RE: Block F Rezoning/OCP Amendment Application Response to UEL Letter dated Feb 6, 2014

Re: Block F Development Approval Response from UEL dated February 6, 2014

To:	Steve Butt	From:	Steve Jeffares
Cc:	Gordon Easton	Date:	March 5, 2014
Project #:	Block F, 545-40	File:	12-125-03
Re:	Musqueam Block F – Development Approval Information

DATE: March 26, 2014
PROJECT: 4912-01
NO:
PROJECT: Block F Development, University Endowment Lands
SUBJECT: Response to UEL Staff Comments Regarding the Transportation Assessment Report

SHEET 8 OF 8

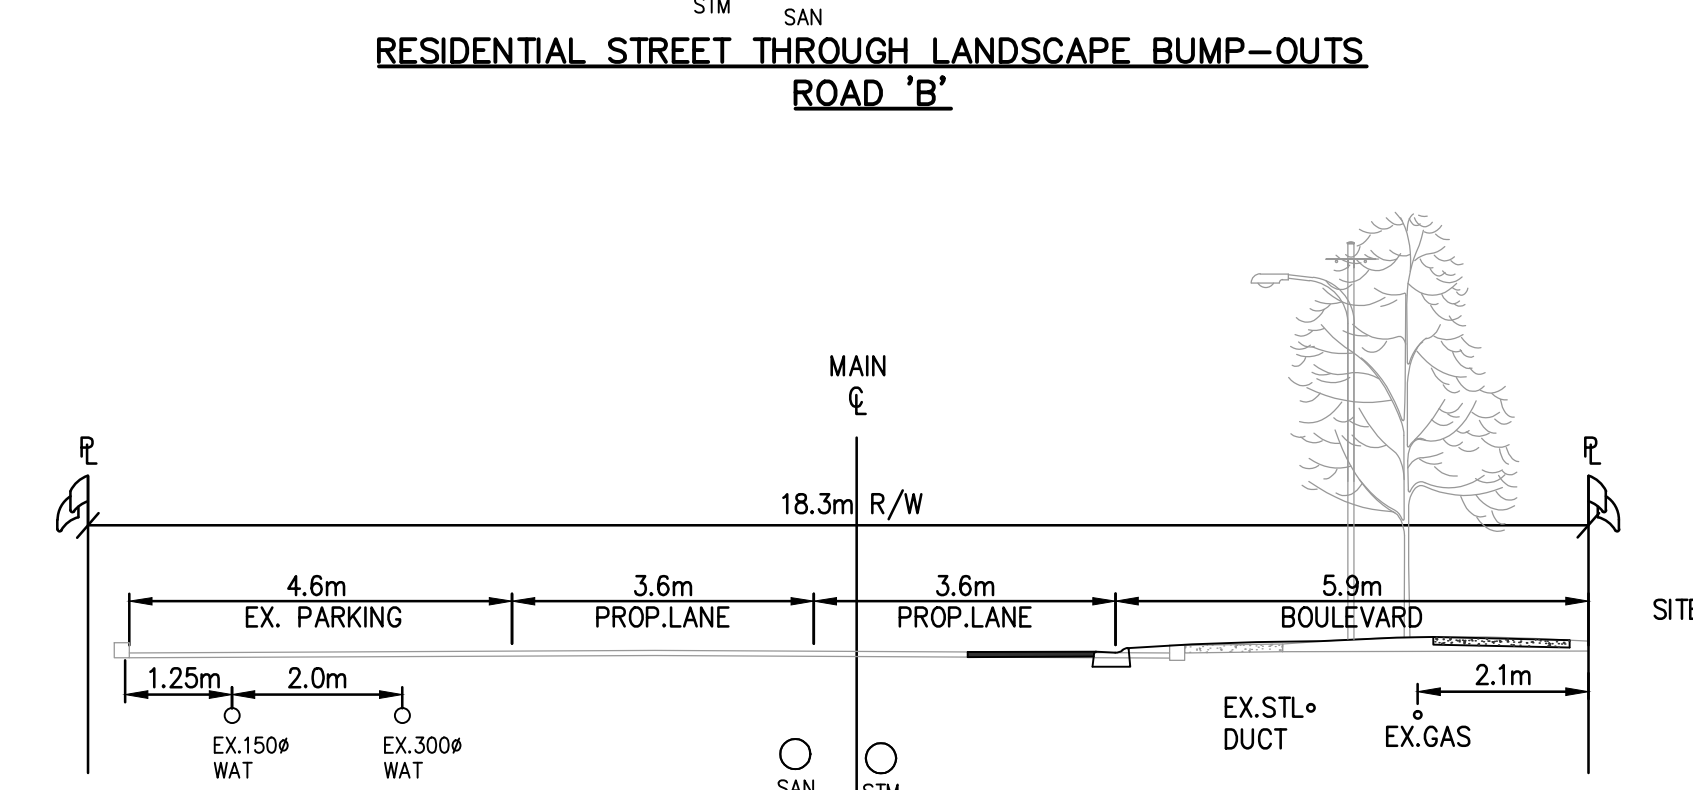
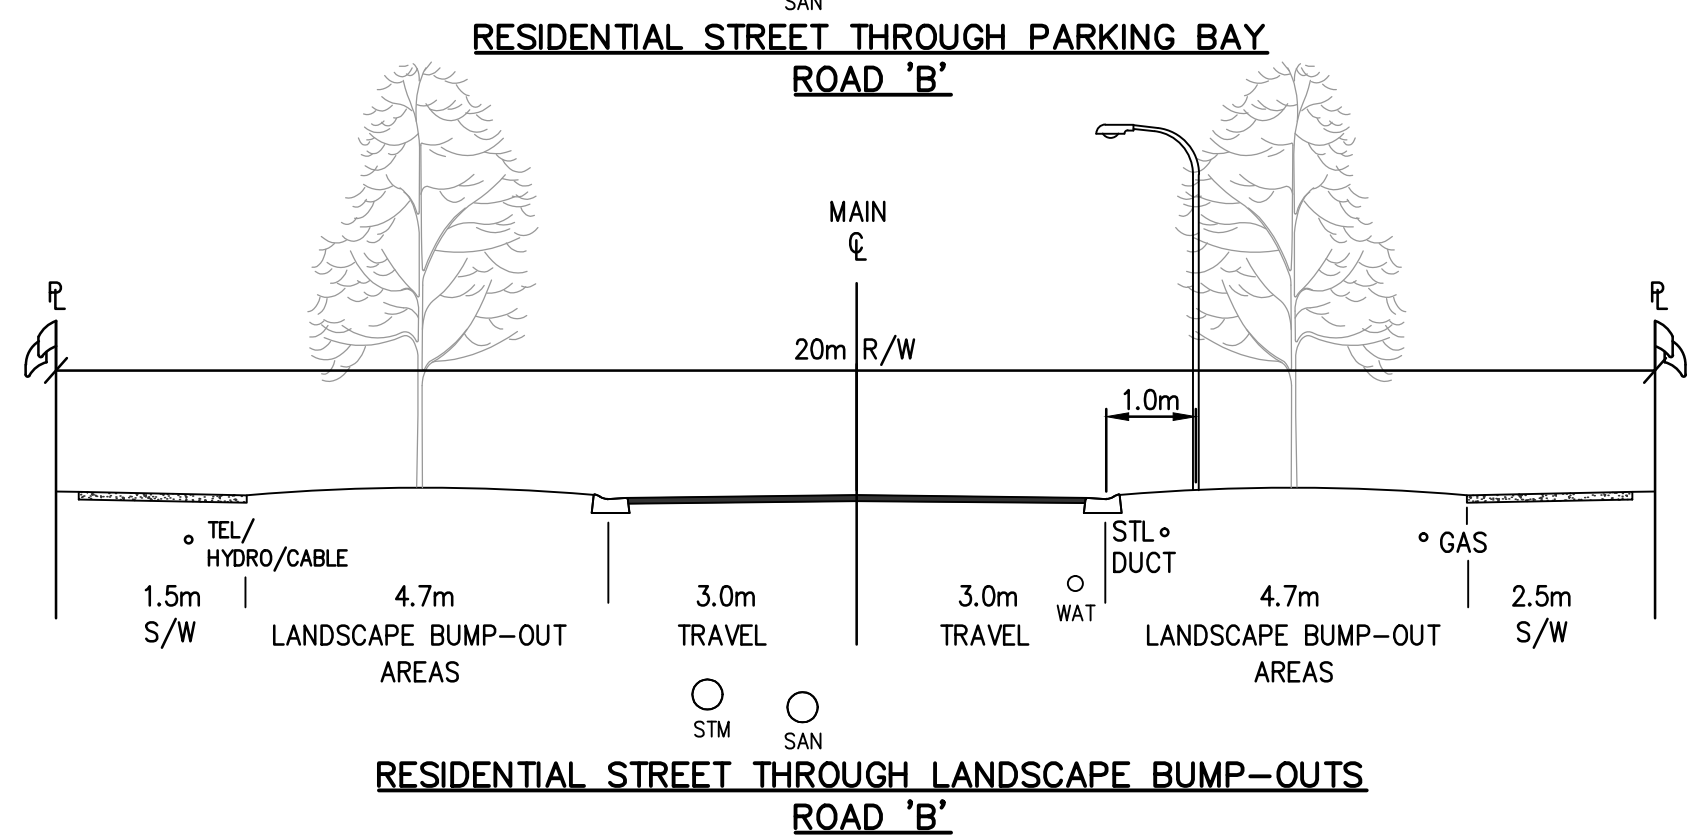
3f. Road Cross-sections: Please provide detailed cross-sections with complete measurements for both University Blvd. and Acadia Rd. To demonstrate that there is sufficient width for what is proposed. Please show the "worst case scenario" (e.g. where there is the least amount of available setback). Please provide a larger, to-scale version of Figure 2.17 that shows conceptually sufficient measurements to assess the feasibility of this plan.

The Landscape Plan has been updated. Also, for detailed measurements, please refer to the updated Civil Plan. Based on the Landscape and Civil plans, it is confirmed that there is sufficient width to accommodate the proposed cross-sections.
